**Re: City of Austin Technical Review/Request for Changes  
on CAMPO 2040 Regional Transportation Plan**

## City of Austin Summary Comments on the CAMPO 2040 Plan

Project Title: CAMPO 2040 Plan Detailed Review Comments

## Report: CAMPO 2040 Plan

Map 1

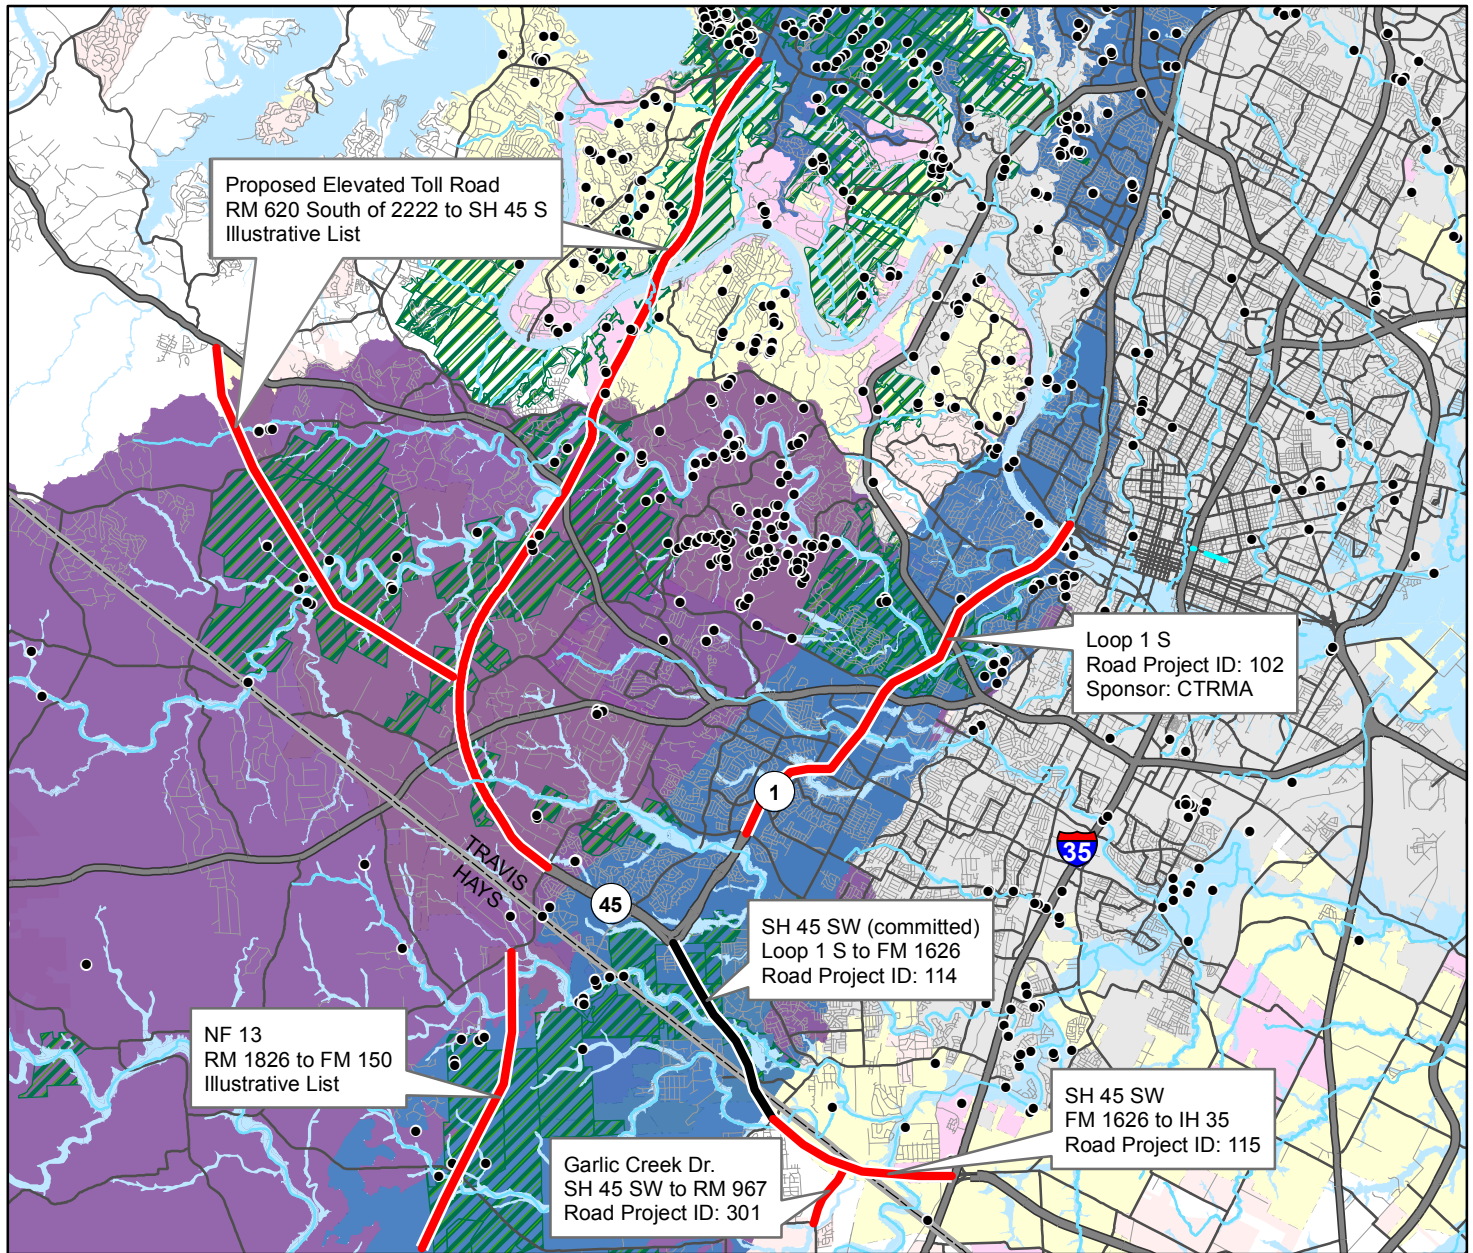
Specifically, City of Austin staff does not support the following Projects as proposed and requests withdrawal of the items. These projects, as well as others proposed in environmentally-sensitive areas, are illustrated in *Map 1* and outlined as follows:

- **Loop 1, Cesar Chavez to Slaughter, Road Project ID: 102, Sponsor: CTRMA, page 167**

This project is described as increasing the capacity of Loop 1 South with two express lanes in each direction. This differs from what was in the previous, CAMPO 2035 *Regional Transportation Plan*, which proposed the project as only one express lane in each direction. City staff has serious concerns regarding the technical feasibility of the project and the evaluation of the impacts of the project on connecting roadways (for example, the capacity of Cesar Chavez to absorb **two** new direct connects from Mopac South, in addition to the Express lane direct connect from Mopac North planned to open in the next year), as well as the environmental implications of the surrounding area. Moreover, the project is entirely in the City of Austin and Travis County jurisdictions, and as such, City Council should be given the opportunity to understand the proposed project changes. Therefore, ATD requests that the 2040 Project Plan definition remain consistent with the definition in the CAMPO 2035 Plan (one primary express lane in each direction.)

- **SH 45 SW, Loop 1 S to FM 1626, Road Project ID: 114, Sponsor: CTRMA/TxDOT, page 168**

Described as a four-lane tolled freeway with a 2015 Let Year, which is the year that funding is available for a project. This is the Committed, controversial SH 45 SW that was recently environmentally cleared by TxDOT to proceed into final design and construction. The City of Austin objects to the environmental review and mitigation strategy for this proposed project because we believe the FEIS does not support a "Finding of No Significant Impact." Similar to the draft EIS, the FEIS falls short in its consideration of project alternatives, in the transportation analysis, in the evaluation of the effectiveness of temporary and permanent water quality controls, and in its assessment of potential impacts to endangered species, sensitive karst

- **SH 45 SW-E, FM 1626 to IH 35 S, Road Project ID: 115, Sponsor: Hays County/Buda, page 168**  
This project is described as the environmental and preliminary engineering analysis for SH 45 SW, from FM 1626 to IH 35. This piece, which would complete SH 45 SW from IH 35 and Loop 1 S, and falls within the City of Austin's extraterritorial jurisdiction (ETJ), is inconsistent with *Imagine Austin*, as noted above, and the City is on record in opposition to SH 45 SW in this area.

- **Proposed elevated Toll Road, RM 620 South of 2222 to SH 45 S, Illustrative List, Sponsor: Lakeway, page 205,**  
The proposed project is similar to the 1984 "SH 45 Western Outer Loop", and is a study in the Illustrative List for a six-lane, elevated toll road. This proposed new roadway would traverse through the City's full-purpose jurisdiction and ETJ, and through areas designated in the Balcones Canyonlands Conservation Plan (BCCP) and put the City and Travis County's federal permit to protect endangered species at risk. In addition, the project would require a new western bridge over Lake Austin, and cross City of Austin Water Quality Protection Lands (WQPL), which can pose a threat to the quality of future City of Austin water supplies. While the Austin Transportation Department (ATD) is on record for objecting to this project, the City of Austin's Watershed Protection Department and Austin Water Utility would also like to emphasize that they too do not support this project due to environmental issues and constraints. *Map 1* demonstrates the project is contrary to *Imagine Austin* and City staff will request that it not be considered for further study. Austin Transportation Department (ATD) staff requests that alternative, existing roadways be considered for further study to address the mobility concerns of this area (e.g. Loop 360, RM 620, RM 2222, and SH 71).

- **NF 13, RM 1826 to FM 150, Illustrative List, Sponsor: Hays County, page 208**  
This project replaced what would have been the Escarpment extension to connect SH 45, west of Loop 1 S, to FM 150 in Hays County. This project is presently described as a **new**, two-lane undivided, major arterial, which would provide a north/south connection between RM 1826 to FM 150. While much of the proposed project falls outside of City of Austin jurisdiction, it would traverse through the City's Water Quality Protection Lands and/or Conservation Easements that are protected in perpetuity, that were authorized by voters to protect source water watersheds that serve Barton Springs, and can pose a threat to the quality of future City of Austin water
